KITTERY TOWN PLANNING BOARD MEETING

AGENDA for Thursday, April 9, 2015

ITEM 1 – Bartlett Hill Multifamily Cluster Subdivision – Subdivision Preliminary Plan Review

**RE: Town of Kittery, Planning Board Services
Bartlett Hill Subdivision Preliminary Review #3
Route 236 and Fernald Road, Tax Map 28, Lot 14
CMA #591.75**

SHEET TITLE:
 SUBDIVISION PLAN
 CLUSTERED MULTIFAMILY
 DEVELOPMENT

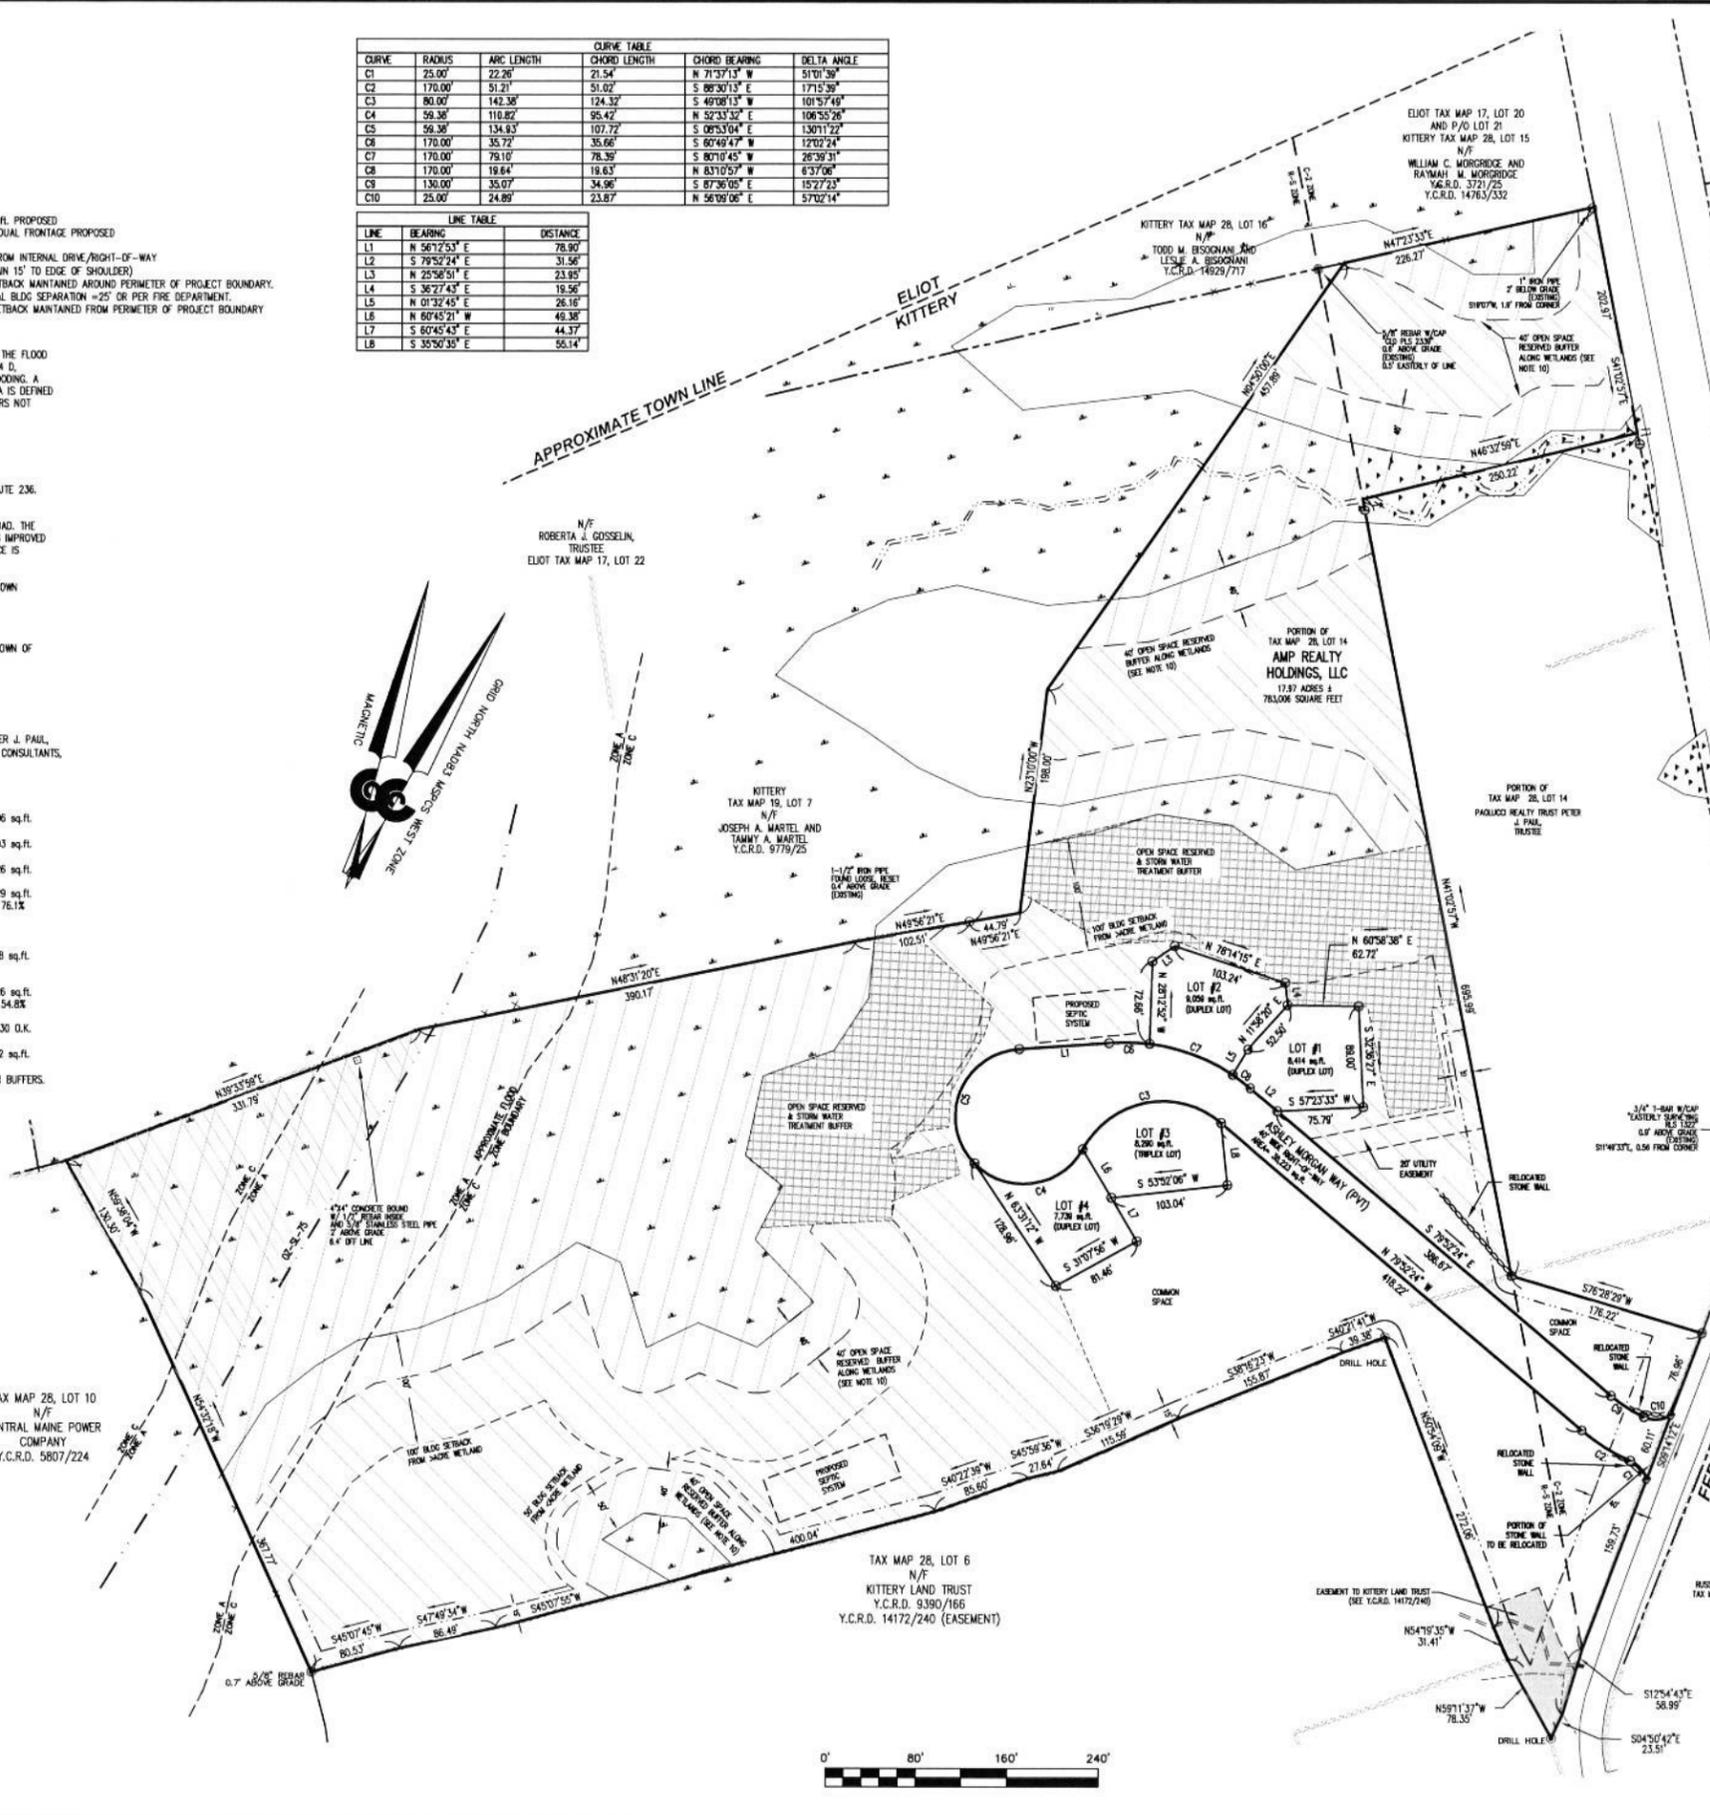
- 8) *The drawing, labeled Sheet 1, should be entitled "Subdivision Plan" rather than "Clustered Multifamily Development". In addition to the drawing title the plan must have the following information:*
- a) *-net residential acreage calculations*
 - b) *-open space calculations*
 - c) *-all easements and covenants, including MDEP stormwater buffers*
 - d) *-list all modifications to town standards, i.e. 40-foot ROW rather than 60 feet*
 - e) *-show/identify maximum number of residential units for each lot proposed*
 - f) *-show the actual open space lots; reserved and common and identify their respective square foot area.*

UPDATE: The comments appear to have been addressed, however the net residential acreage calculations need to relate better to the deductions found in 16.7.8 Land Not Suitable for Development. In addition, there should be an area identified by the high intensity soils information (in this case for Scantic soils) on the Existing Conditions Plan (C-1) that correlates with the calculations on the Subdivision Plan.

Item f) is not entirely addressed, square area shown, however no distinct lot(s). Staff recommends the lots be defined as suggested in the attached plan exhibit ATT. 1.

SHEET NUMBER:
C6
 SHEET 6 of 7
 PROJECT #12-198.00

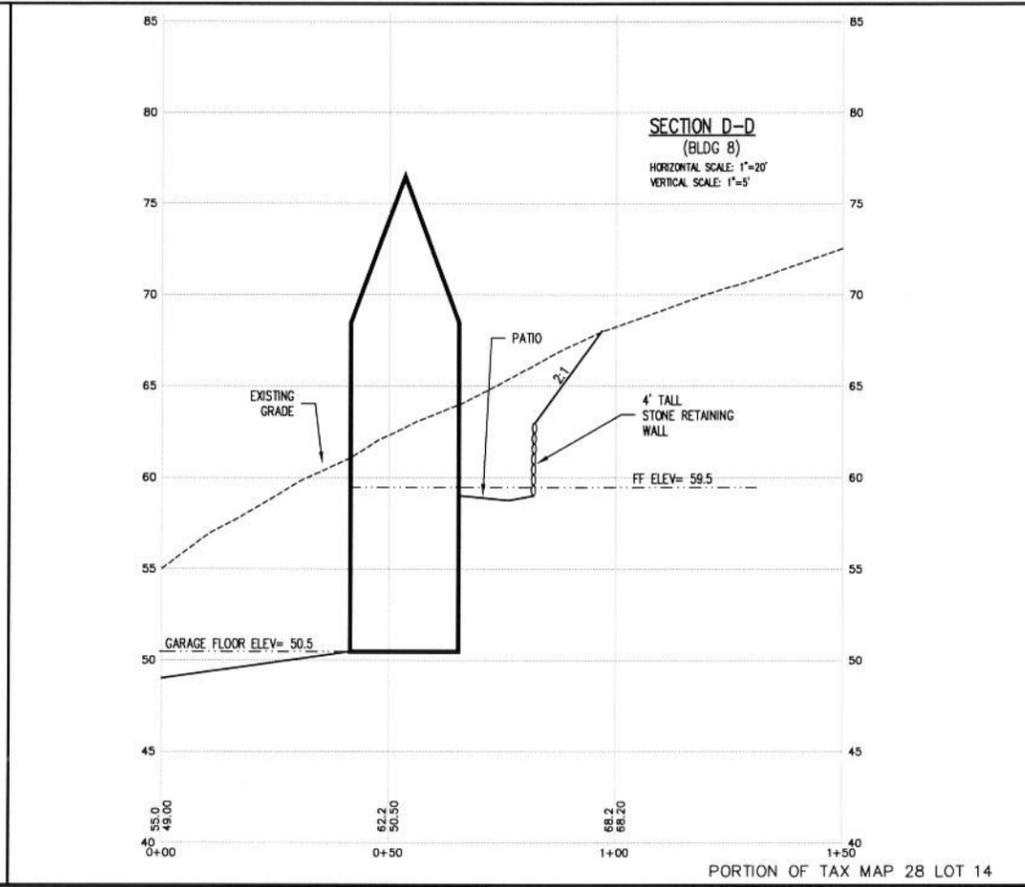
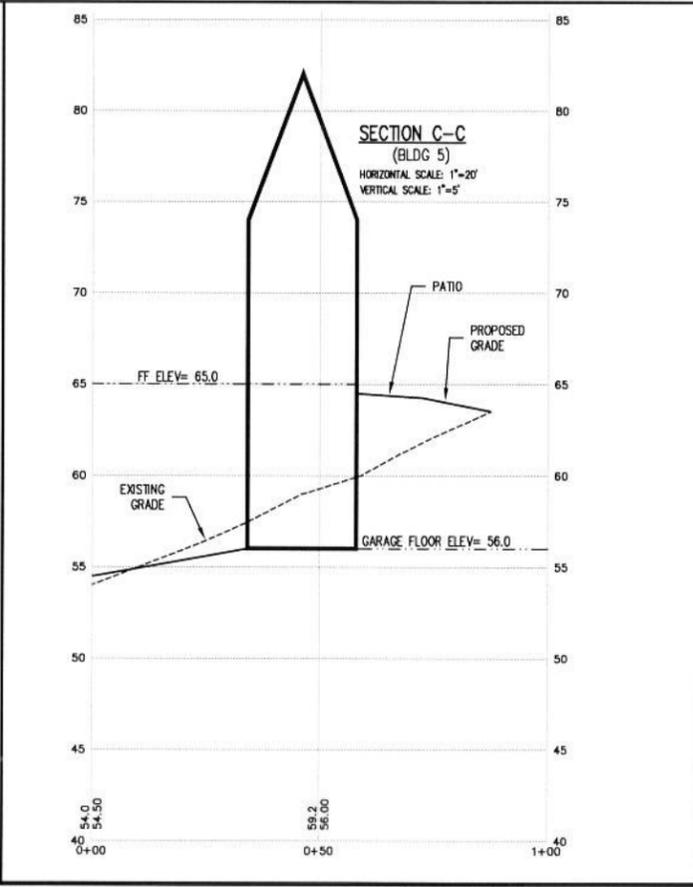
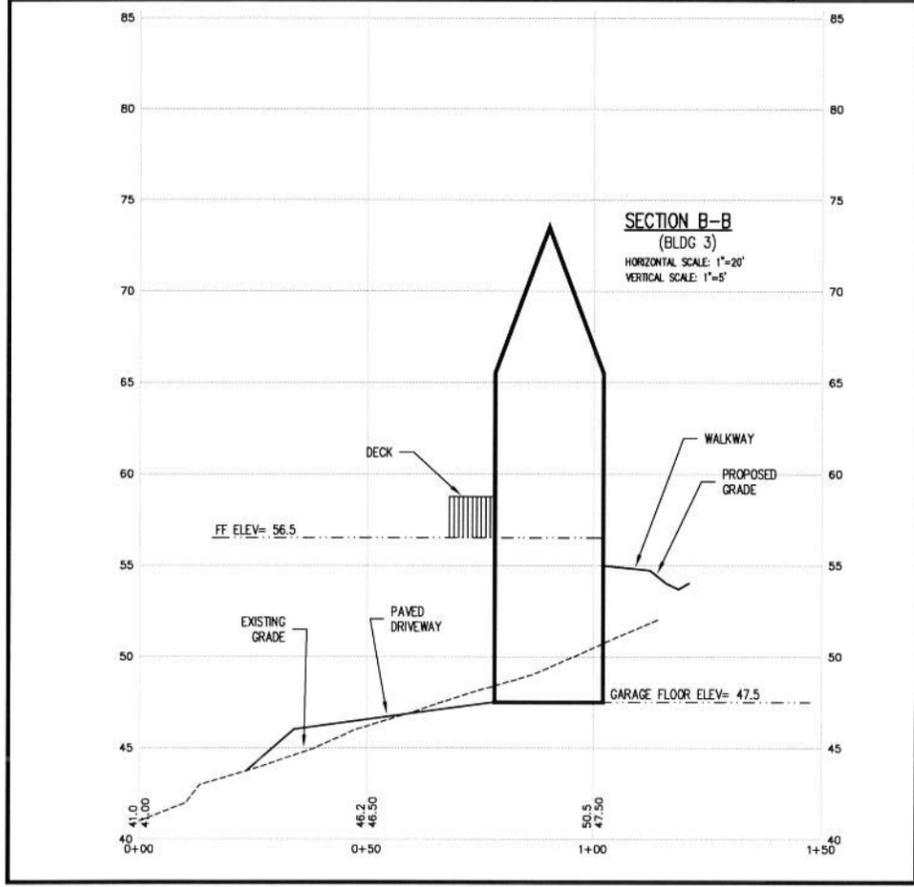
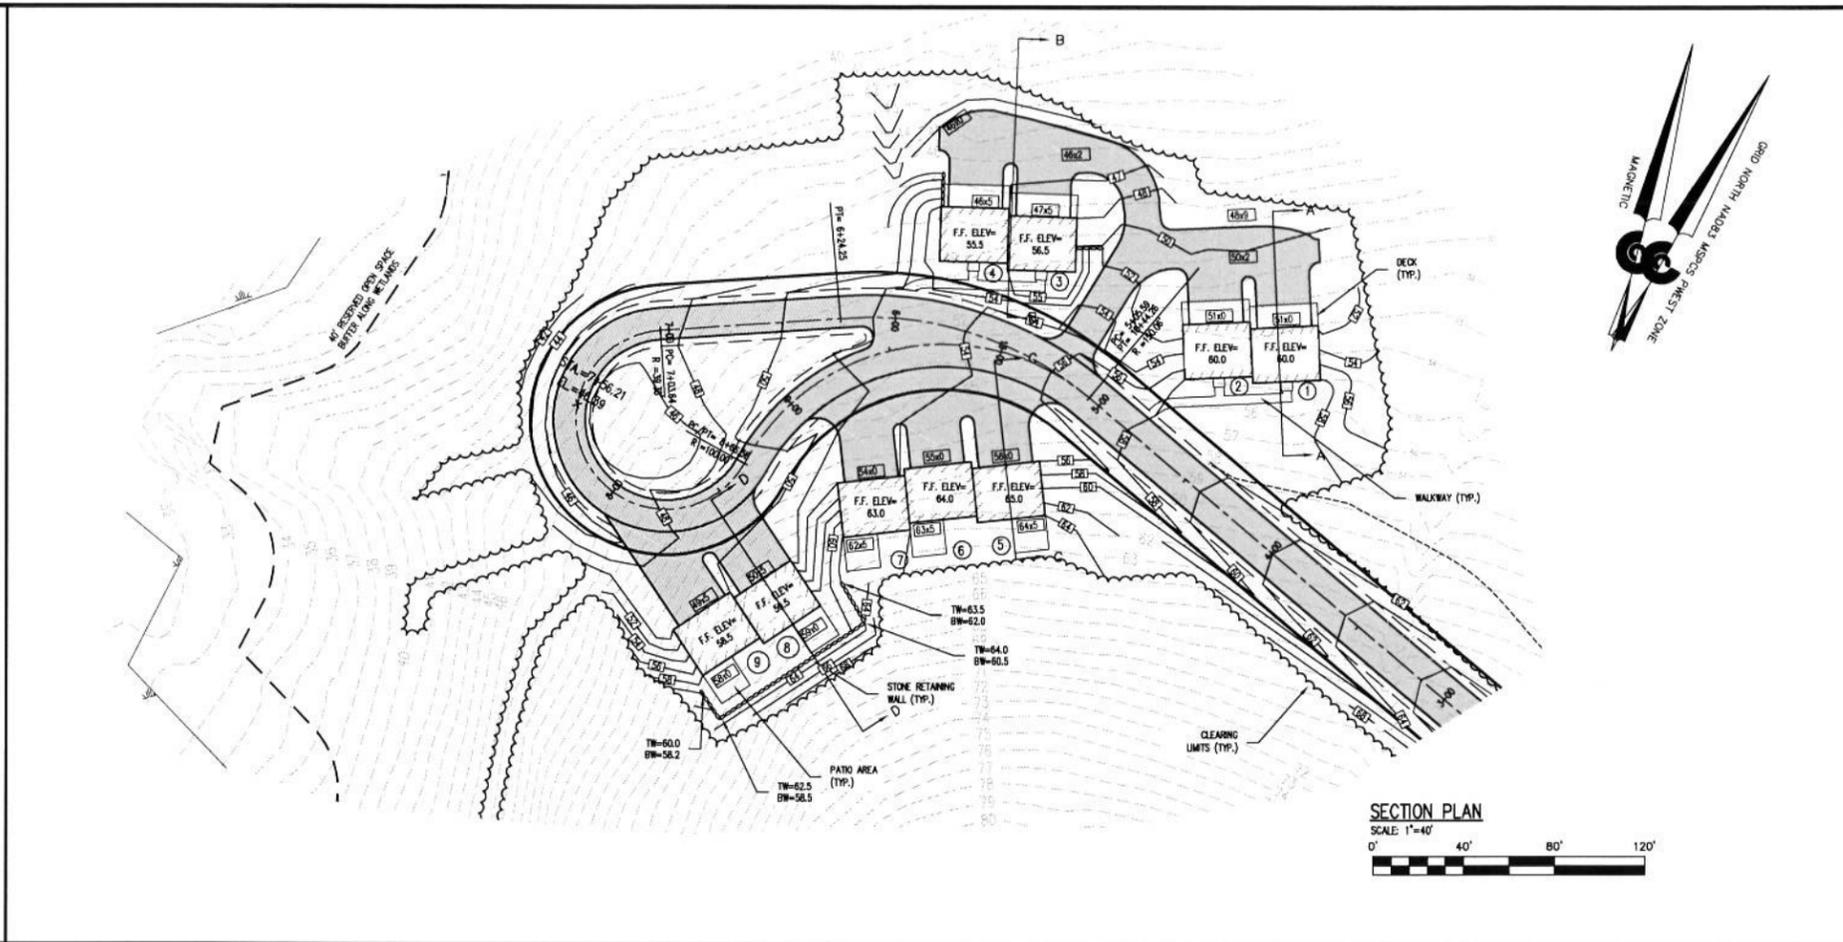
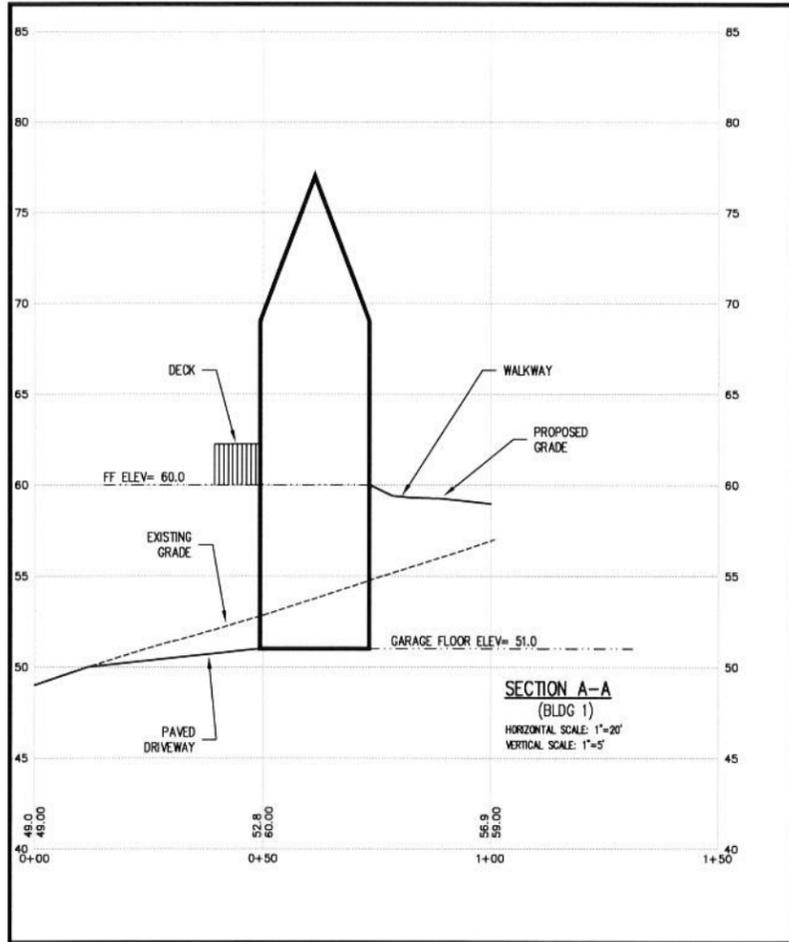
There are four instances where there are encroachments within the required buffer (See Sheet C6): Building 3 & 4 driveway and associated grading; level spreader behind Building 4; force main south of Building 9; and the terminus of the cul-de-sac and associated grading. The Board may want to consider waiving full compliance due to unique site constraints and, in the case of the cul-de-sac, the area has already been disturbed.

UPDATE: The revised plan appears to have removed encroachments to the no-cut/no-disturb buffer area.
